Alert #: SA 17-17

Genie OPA Assembly Reinforcement

170004

Date:	September 22, 2017
Affected Option:	Operator Protective Alarm (OPA)
Models and Serial Numbers Affected:	See pages 4 to 6
Field Install Kits Affected:	125563 - for all Z-45/25 DC models 1255096 and 1276063 - for machines equipped with ALC500 operating system 1255564 and 1273064 - for machines equipped with ALC1000 operating system.
Subject:	Operator Protective Alarm (OPA) mounting
Allowable Hours:	1 hour

Illustration 1

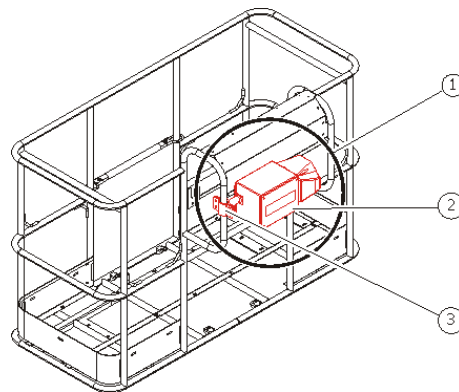
Genie has determined that the Operator's Protective Alarm (OPA) installed on any of the models listed on page 6 is equipped with a mounting bracket that may become loose. **This may cause the OPA assembly to fall off the machine resulting in a collision hazard.**

This Safety Notice requires installing a reinforcement structure around the OPA assembly.

Illustration 4

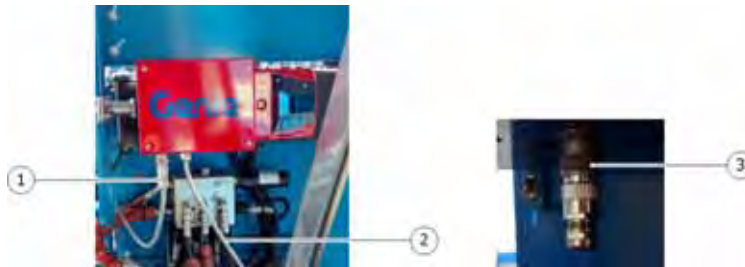
You may continue using the OPA assembly with the machine. However, the OPA assembly must be removed from the machine before transport. Re-install the OPA assembly at the worksite.

- 1 Locate the OPA harness connectors (items 1 and 2).

- 2 Disconnect harness connector 1 from the red OPA control box. Secure the harness.
- 3 Disconnect harness connector 2 from the platform control box or footswitch. Secure the harness.
- 4 Locate the blanking plug (Genie part number 1255030GT) from the machine document box and plug into the platform or footswitch connector where harness connector 2 was removed.
